Access Compliance Report

Public Rights-of-Way

(Curb Ramps)

Intersection ID: 19766	Main Street: ARROWOOD_RD	Cross Street: WHITEHALL_PARK_DR	Location: SW
ADA ID: 61A4069E8957	Ramp Type: Perp	Initial Pass/Fail: Fail	Overall Compliance: No
			Severity Score: 21.25

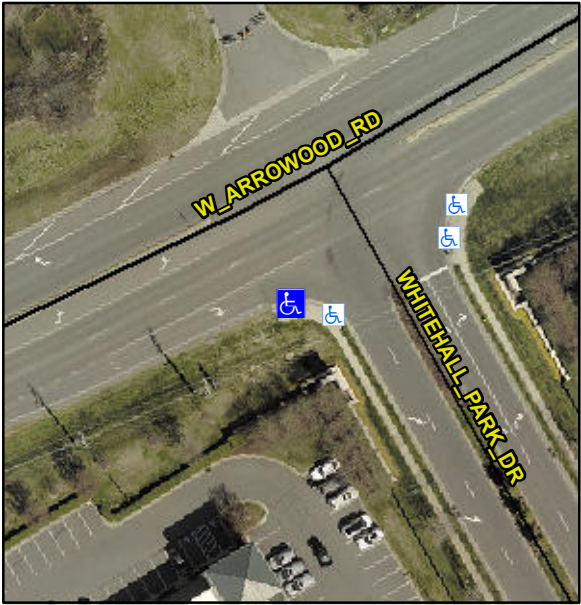
Codes/Mitigation Info/Possible Solution		Field Measurements/Component Compliance			
	Possible Solutions:				
	Remove & Replace Entire Ramp.				
	Surveyor Notes:				
	N/A				
	PROW/ADA:				
	R304.5.1, R304.5.3				
Street 1 Name	W ARROWOOD RD				
Stop Condition-Street 2	None				
Street 2 Name	N/A				
Stop Condition-Street 1	N/A				
Total Cost:		\$	1850.00

Compliance	Description	Data	Compliance	Description	Data
N/A	Ramp Length (in)	95.0	Yes	Ramp Slope (%)	6.5
No	Ramp Width (in)	37.0	No	Ramp XSlope (%)	5.6
N/A	Flare Type LT	N/A	N/A	Flare Type RT	N/A
N/A	Flare Slope LT (%)	N/A	N/A	Flare Slope RT (%)	N/A
N/A	Flare Traversable LT?	N/A	N/A	Flare Traversable RT?	N/A
N/A	Landing Length (in)	N/A	N/A	DWS Provided?	N/A
N/A	Landing Width (in)	N/A	N/A	DWS Contrast?	N/A
N/A	Landing Slope (%)	N/A	N/A	DWS Length (in)	N/A
N/A	Landing X Slope (%)	N/A	N/A	DWS Full Width?	N/A
N/A	Landing Curb? (Y/N)	N/A	N/A	DWS Offset (in)	N/A
N/A	Shared Landing?	N/A			
N/A	Gutter Ponding?	N/A	N/A	Gutter Slope (%)	N/A
N/A	Gutter Lip Ht (in)	N/A	N/A	Gutter X Slope (%)	N/A
N/A	Painted X Walk1?	No	N/A	Painted X Walk2?	N/A
	X Walk 1 Direction	To N		X Walk 2 Direction	N/A
N/A	X Walk 1 Width (in)	N/A	N/A	X Walk 2 Width (in)	N/A
	X Walk 1 Slope (%)	3.2		X Walk 2 Slope (%)	N/A
	X Walk 1 X Slope (%)	2.0		X Walk 2 X Slope (%)	N/A
